This software updates or alters the functions and features noted below. The instructions and information that follow are meant as a supplement to the original instruction manual that accompanied the transmitter. Please refer to the original instruction manual where applicable, but replace the steps indicated below with these instructions. Please check to ensure that the update has been installed.

This software updates or alters the functions and features noted below. The instructions and information that follow are meant as a supplement to the original instruction manual that accompanied the T18SZ/T16SZ/FX-36 transmitter. Please refer to the original instruction manual where applicable, but replace the steps indicated below with these instructions. Please check to ensure that the update has been installed.

1. Add Model ID

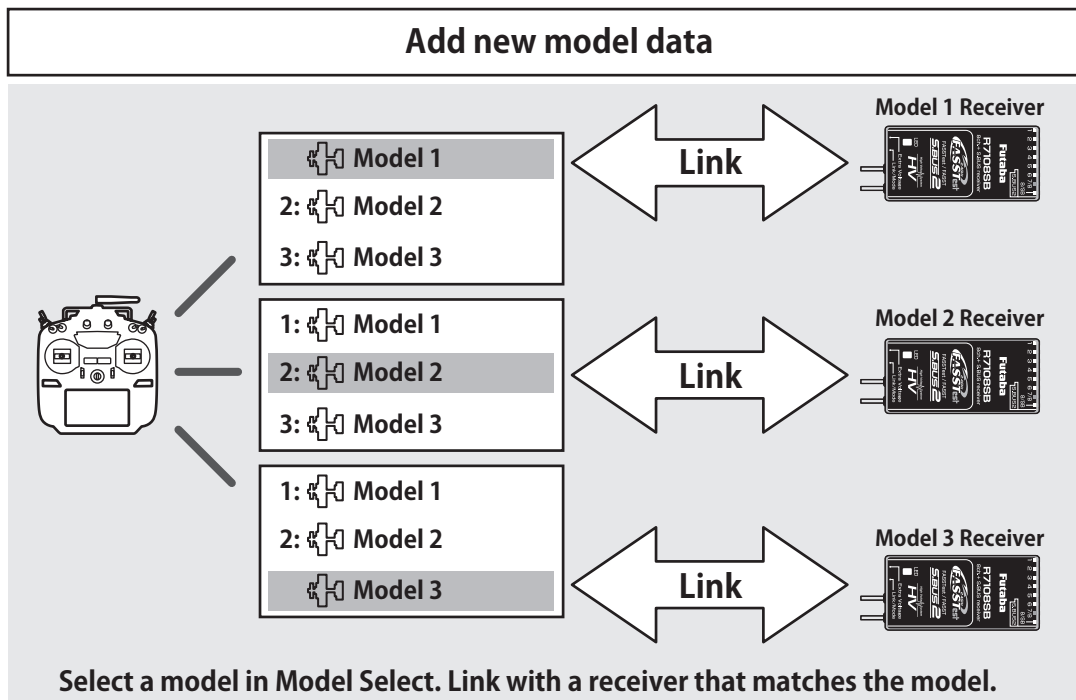
As an added level of safety in the form of Model ID, which will prevent the accidental control of a model when using a different model data by preventing link.

In Ver 3.9 or later software with the model ID function added, model data saved on the SD card cannot be called using the model select function. To use the model data of the SD card, copy the model data to the transmitter. If the model data of the SD card was selected before the update, an error message will be displayed at the first startup after the update, and the model will automatically switch to the model data of the transmitter.

Link is required when a new model is made from a model selection.

- In the system types (FASSTest, T-FHSS) compatible with the model ID function, a unique ID number (model ID) is set to each model data. Linking with a receiver stores the model ID of the model data in that receiver. The receiver operates only when it receives radio waves transmitted using model data that matches the stored model ID. As a result, the receiver does not operate even if model data of an unintended setting is used by mistake, so it is possible to prevent a malfunction due to a model selection mistake.

- If you want to use different model data from the model data that you have been using, link again.
- Model ID feature is enabled only if the system type is FASSTest or T-FHSS. Please note that model ID function can not be used on other systems.
- For safety reasons, model ID function can not be disabled.
- Model ID is automatically set when copying or adding model data.

When using R3004SB

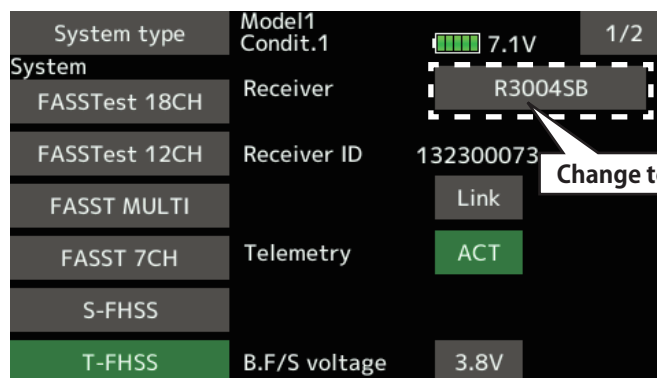
- When using the **R3004SB**, set "Receiver" in the system type screen T-FHSS mode setting to **[R3004SB]**. When using other T-FHSS compatible receivers, set "Receiver" to [Normal].

⚠ R3004SB receiver does not support model ID function.

◆ How to display the Airspeed sensor screen.

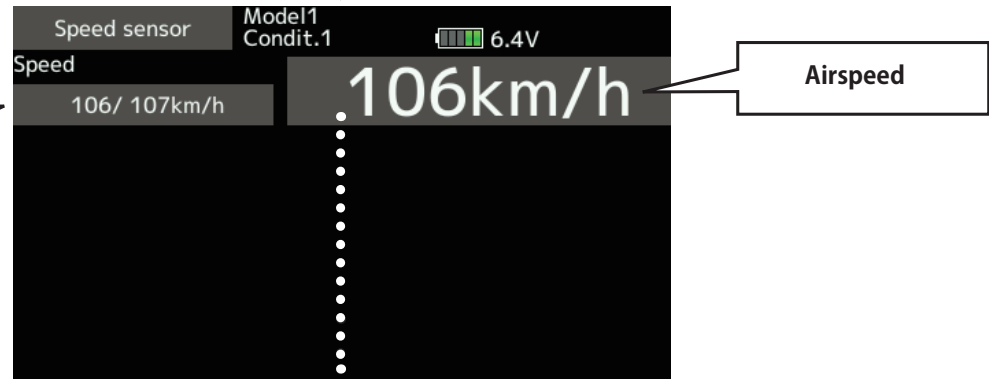
① [Linkage menu] → [Telemetry]

② Tap [Speed sensor]

◆ Alarm setting

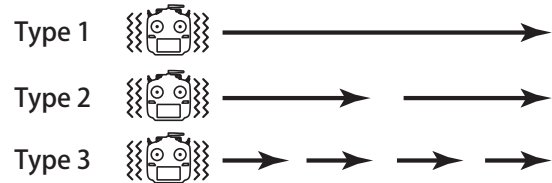
↑ An upward arrow indicates the alarm will sound when the speed reaches above your set value.

↓ A downward arrow indicates the alarm will sound when the speed reaches below your set value.

The ON/OFF switch of Speech is chosen.

Alarm is chosen from Buzzer, Voice, and Inhibit.

2. CRSF Protocol for TBS

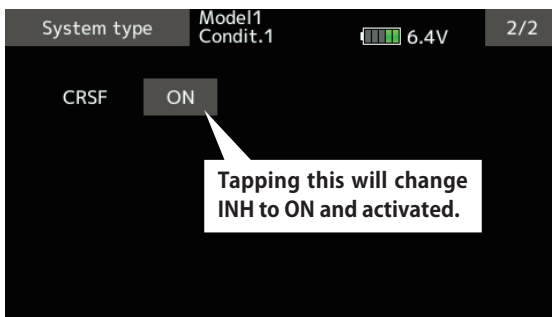
① [Linkage menu] → [System Type] → [Page 2/2] is opened from the transmitter.

② Tap the "CRSF" button to [ON]. A signal conforming to the CRSF standard is output from the S.BUS setting connector (S.I/F) of the transmitter.

■ When using CRSF, the S.BUS servo setting function and [Reload] [Register] [Change slot] functions cannot be used. When setting S.BUS servo and sensor, set CRSF to INH.
